TRANSMITTAL

BROOKFIELD FLOATING BRIDGE

BRIDGE REPLACEMENT PROJECT

FIBER REINFORCED POLYMER (FRP) PONTOON COMPONENT FABRICATION

HULLS 3-8 LAY UP SCHEDULE

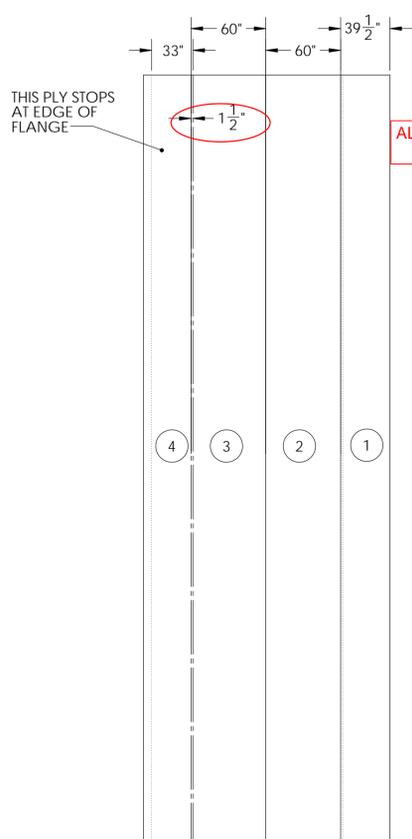
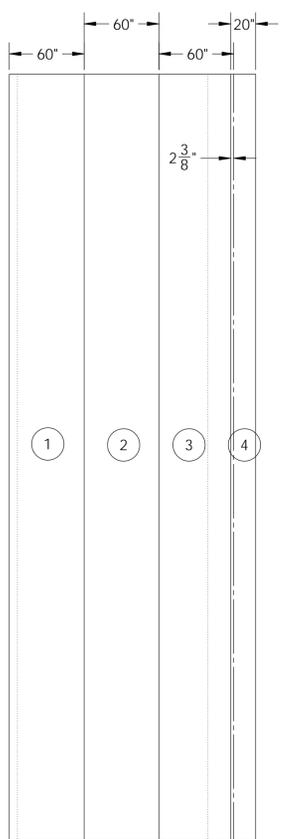
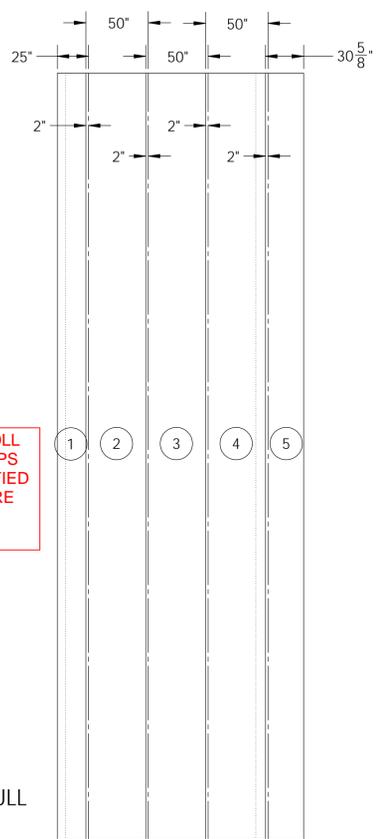
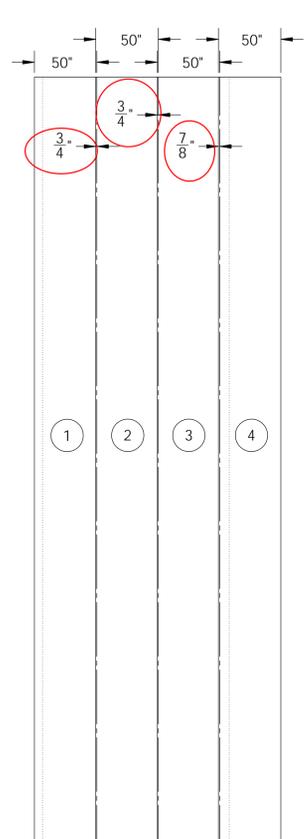
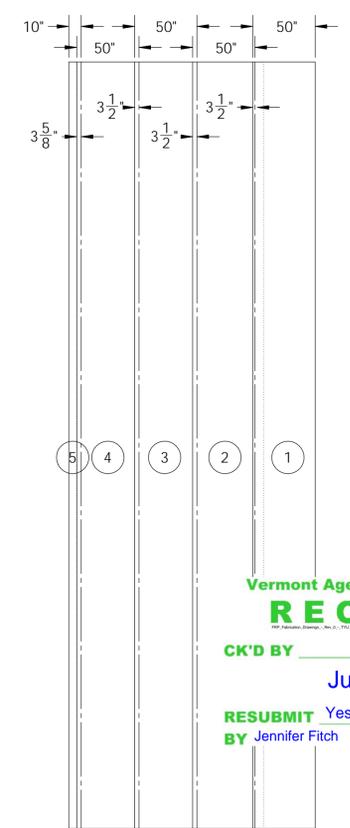
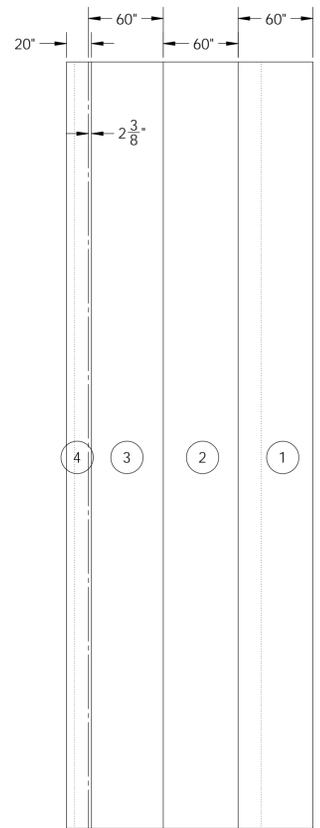
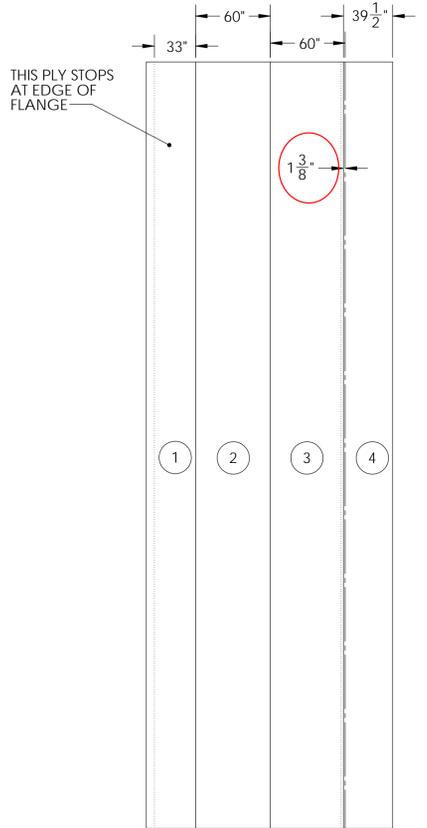
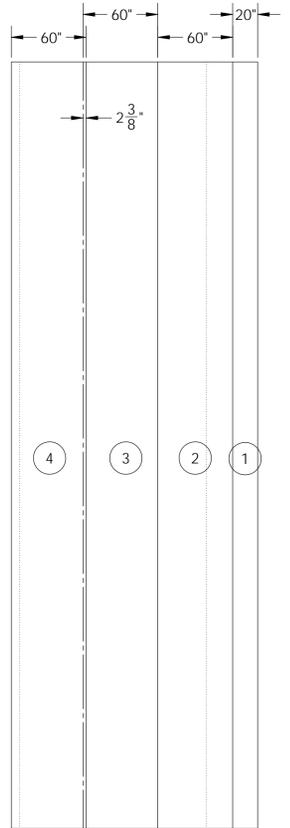
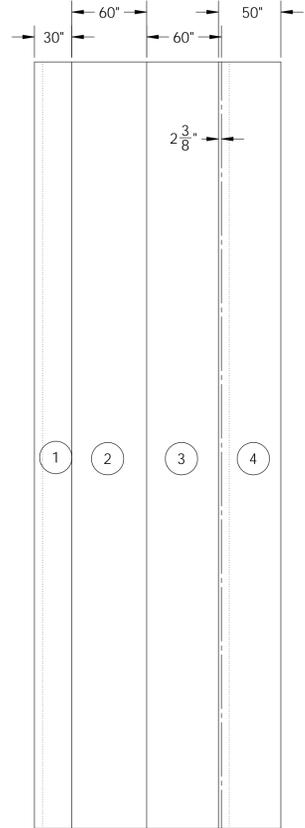
ANY LAPS IN THE ROLL DIRECTION? ALL LAPS NEED TO BE IDENTIFIED TO ENSURE LAPS ARE APPROPRIATELY STAGGERED.

END HULL LAY UP SCHEDULE

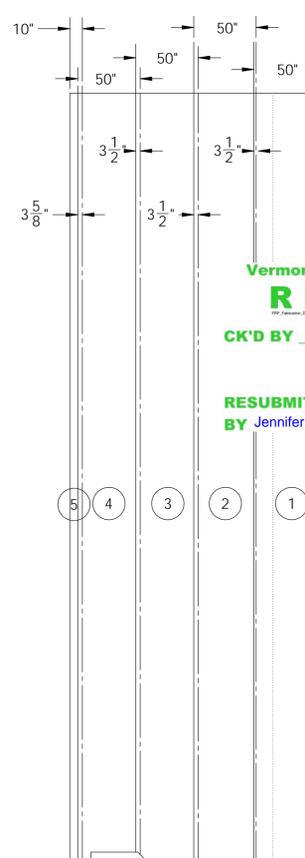
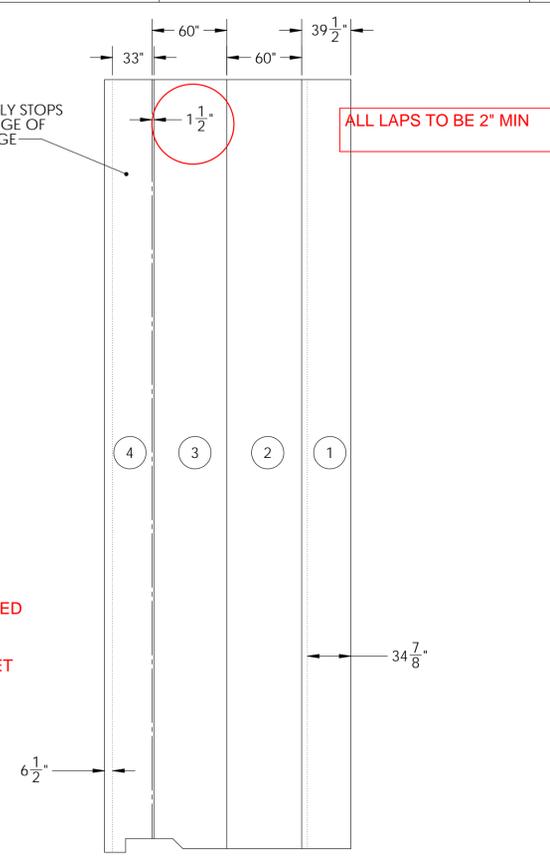
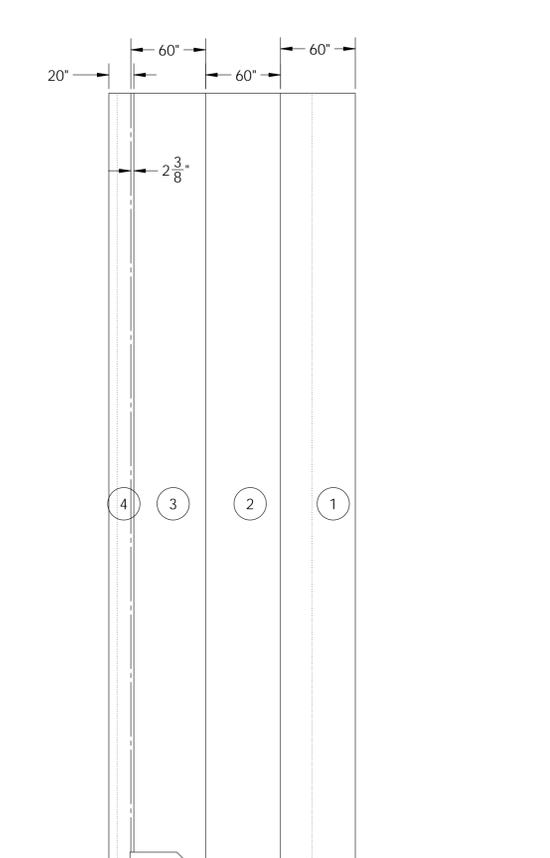
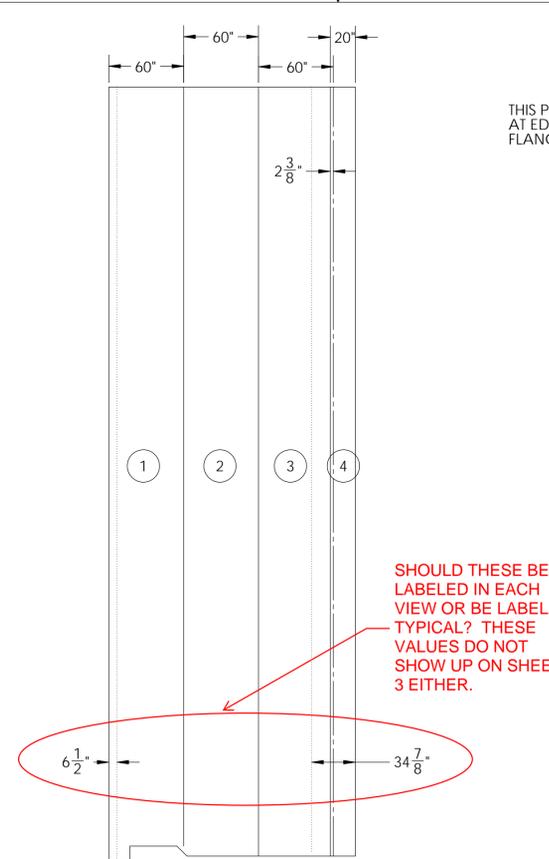
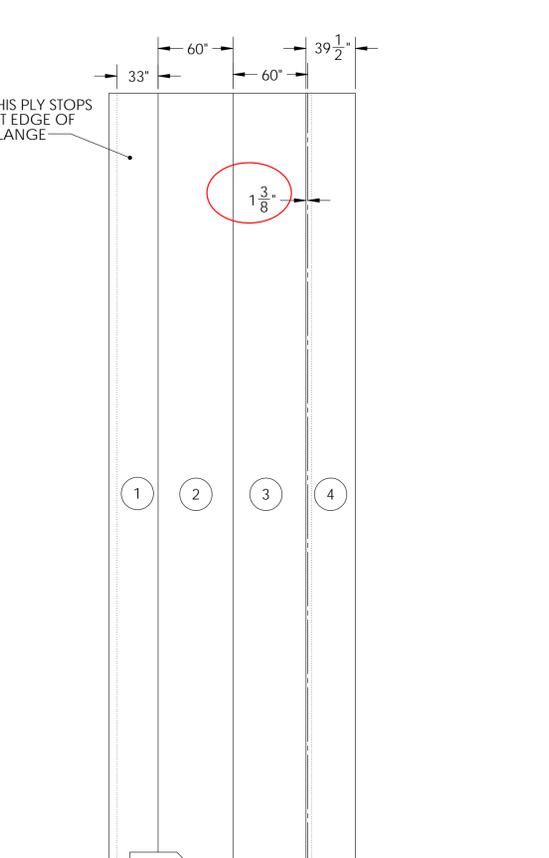
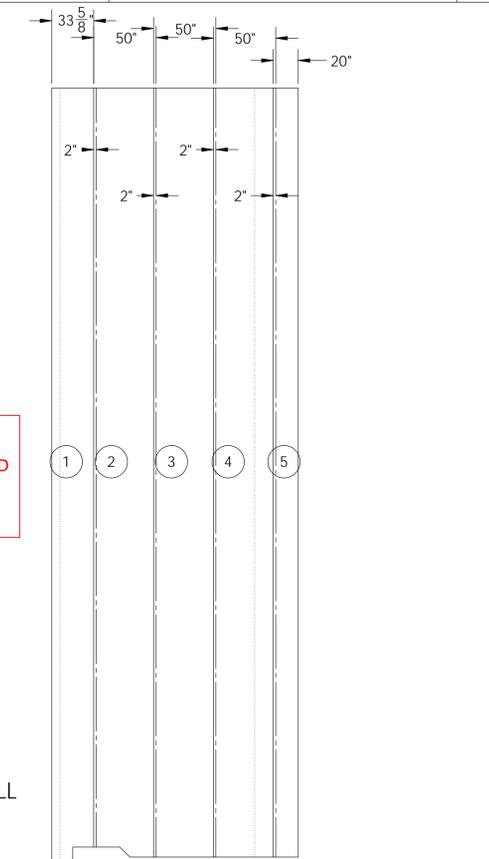
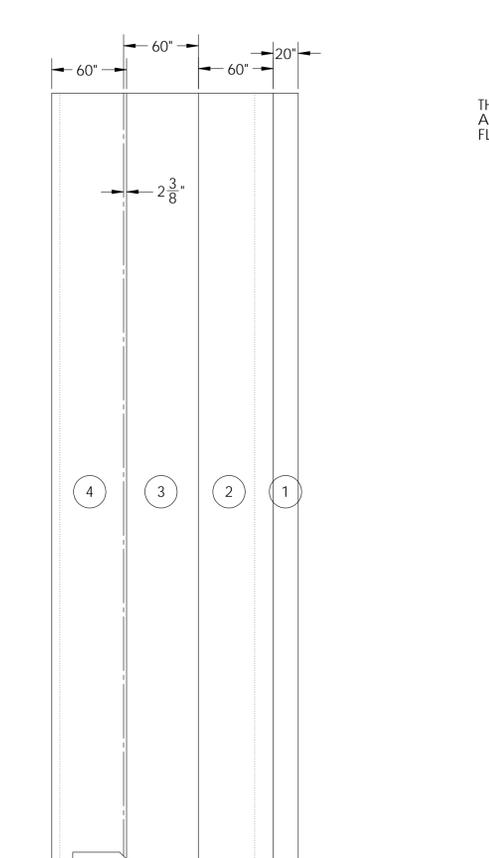
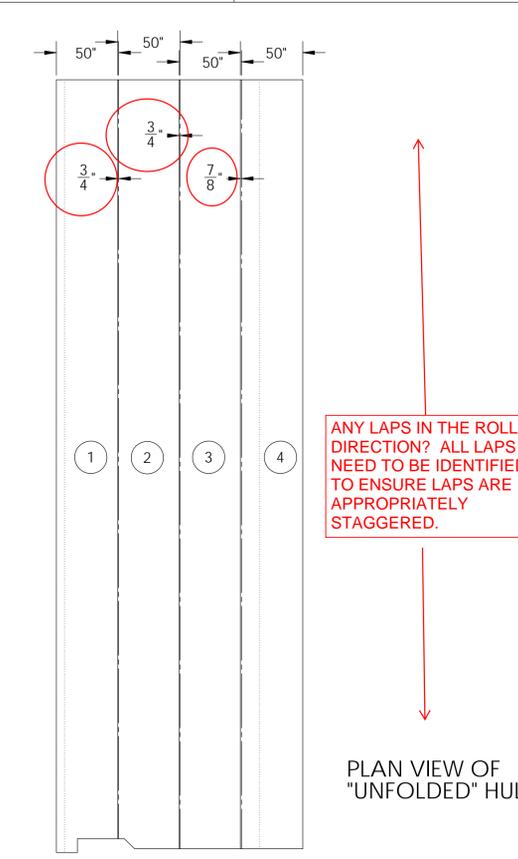
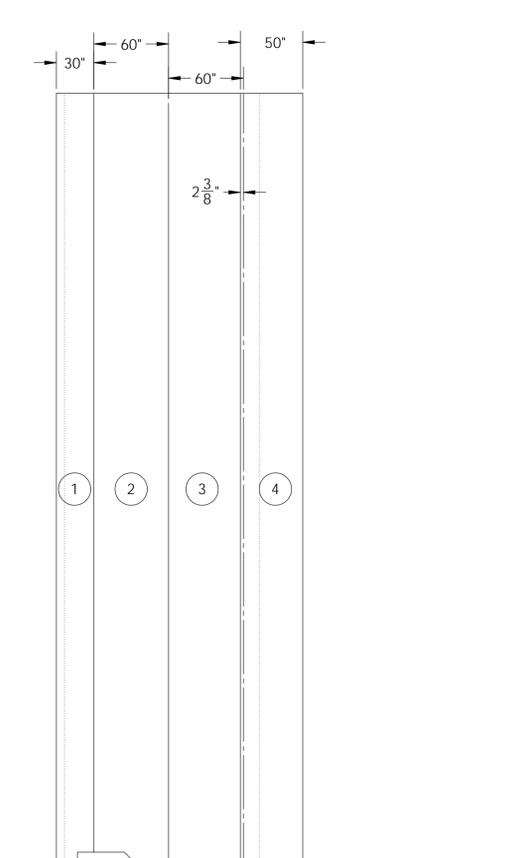
ANY LAPS IN THE ROLL DIRECTION? ALL LAPS NEED TO BE IDENTIFIED TO ENSURE LAPS ARE APPROPRIATELY STAGGERED.

SHOULD THESE BE LABELED IN EACH VIEW OR BE LABELED TYPICAL? THESE VALUES DO NOT SHOW UP ON SHEET 3 EITHER.

PROJECT: BROOKFIELD FRP PONTOONS
CUSTOMER: MILLER CONST. / VTRANS
SHEET: END BULKHEADS LAYOUT SCHEDULE

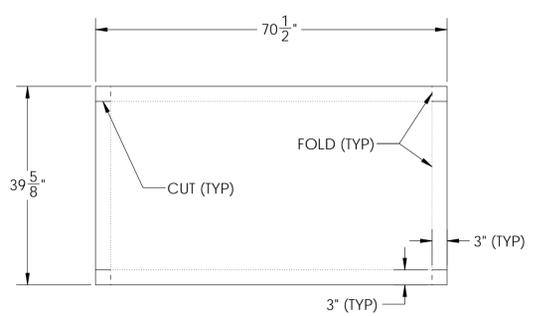
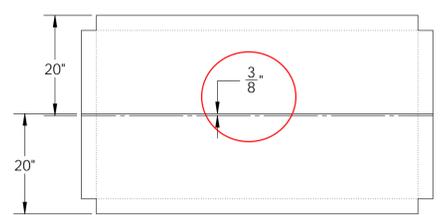
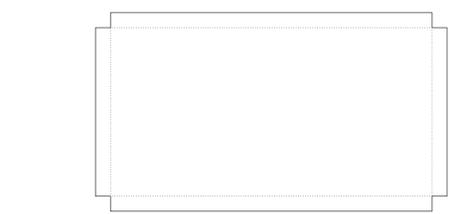
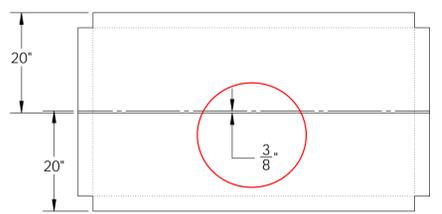
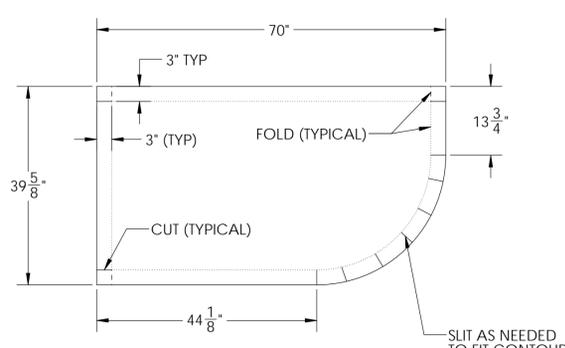
ANY LAPS ANTICIPATED IN OPPOSITE (ROLL) DIRECTION? THESE NEED TO BE IDENTIFIED TO ENSURE PROPER SPLICE STAGGERING

PROJECT: BROOKFIELD FRP PONTOONS
 CUSTOMER: MILLER CONST. / VTRANS
 SHEET: TRANSVERSE ROD BULKHEAD LAYOUT SCHEDULE

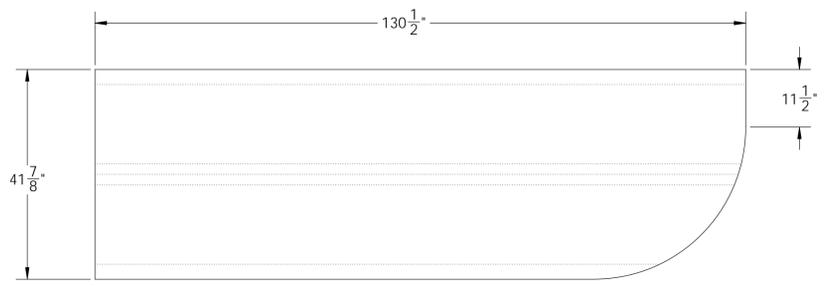
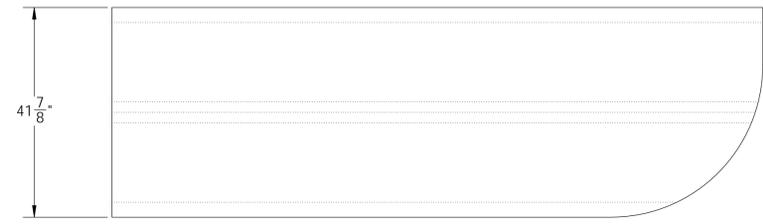
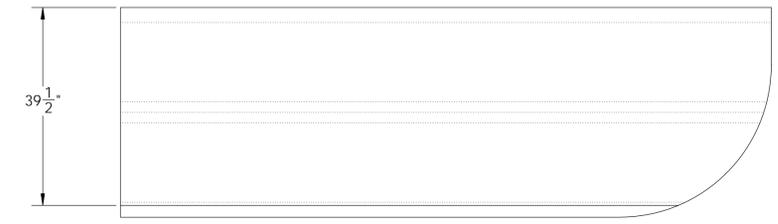
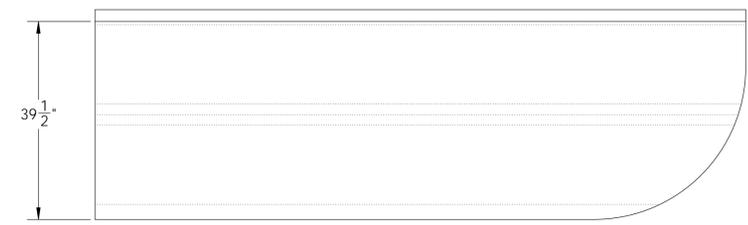
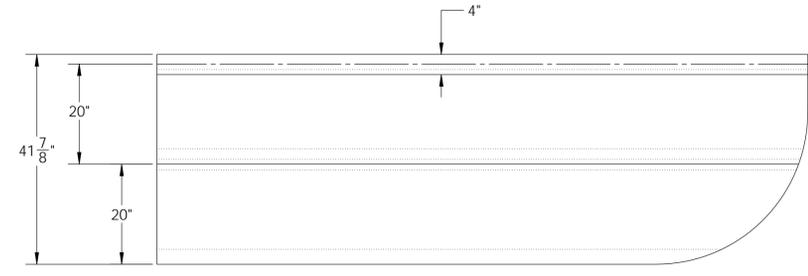
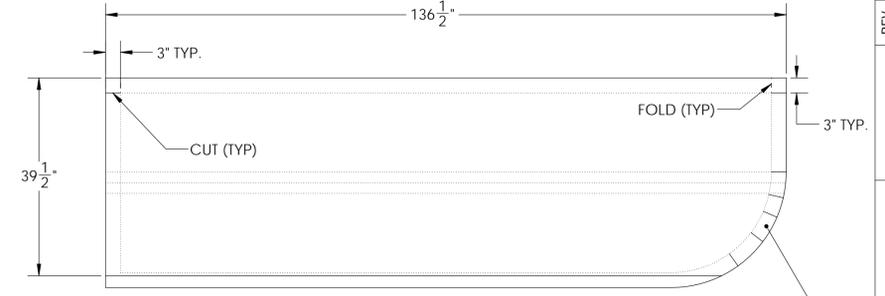
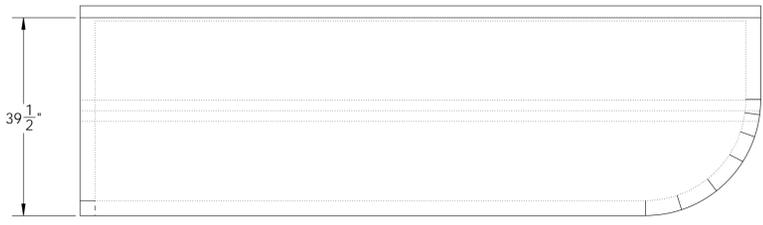
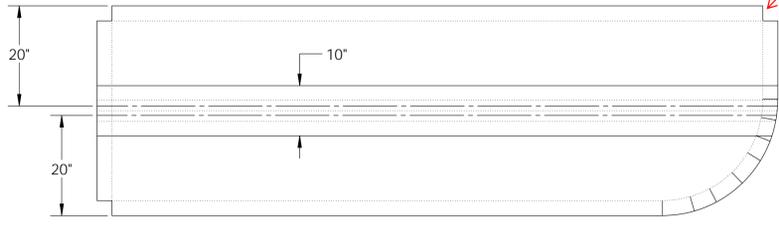
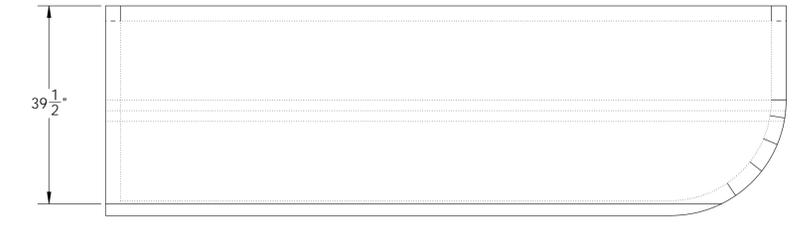
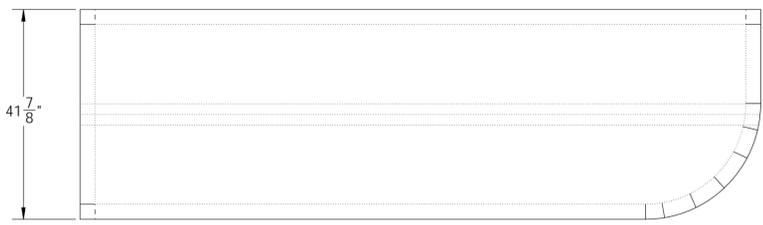
IDENTIFY ALL LAPS (2" MIN)

ARE ALL CORNERS INTENDED TO BE CUT COMPLETELY OFF OR ARE 2 CUTS BEING MADE AND ADJACENT PIECES OVERLAPPED IN THE CORNERS?

SHEET: MIDDLE LONGITUDINAL BULKHEAD LAYUP SCHEDULE

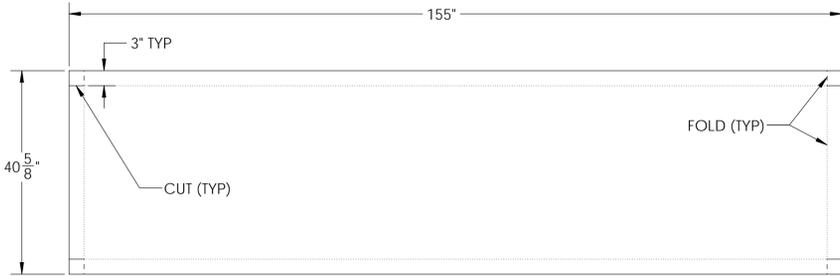
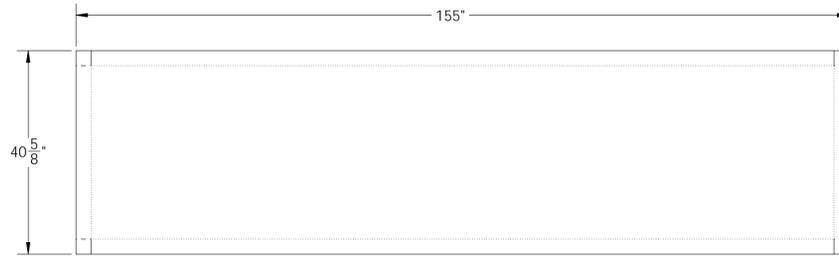
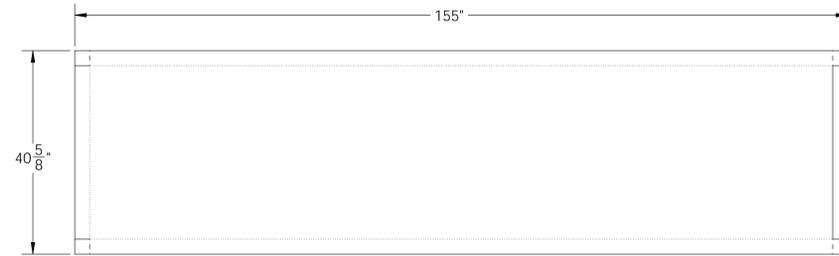
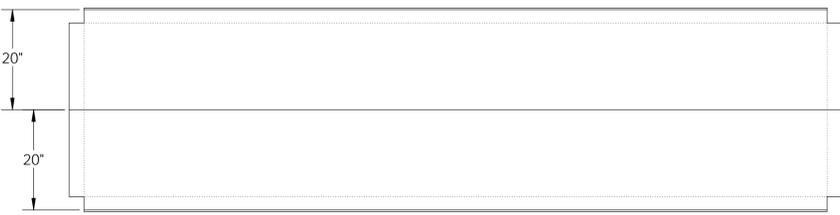
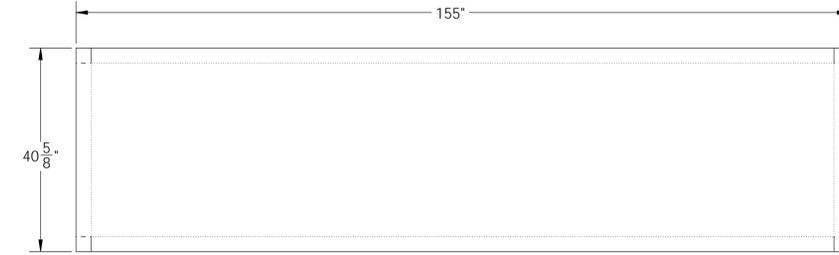
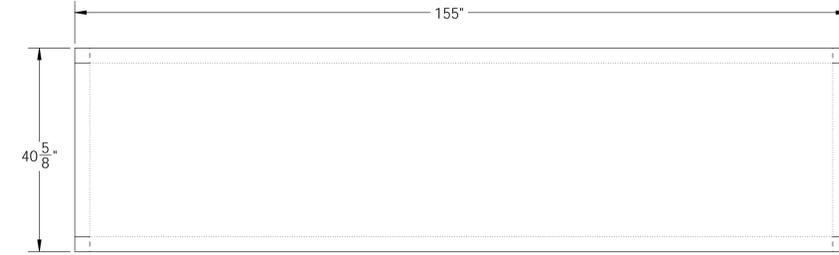
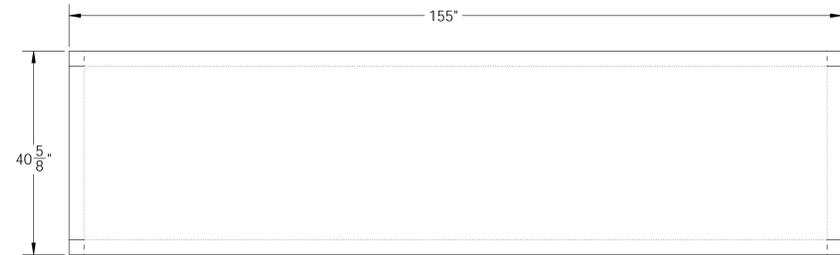
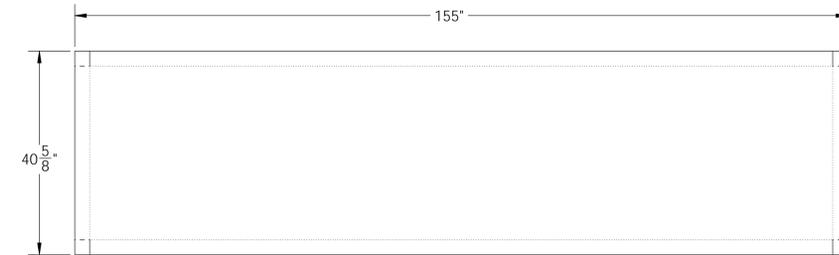
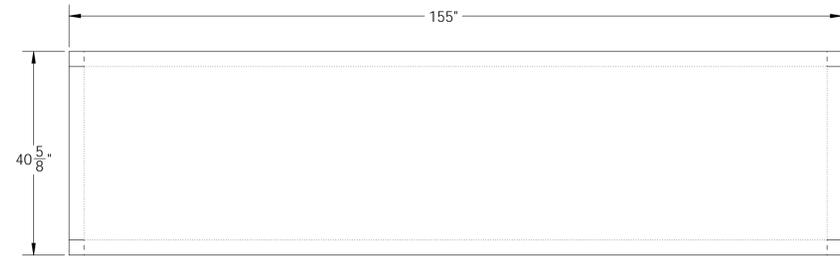
ARE ALL CORNERS INTENDED TO BE CUT COMPLETELY OFF OR ARE 2 CUTS BEING MADE AND ADJACENT PIECES OVERLAPPED IN THE CORNERS?

ALL LAPS TO BE SHOWN (2" MIN)
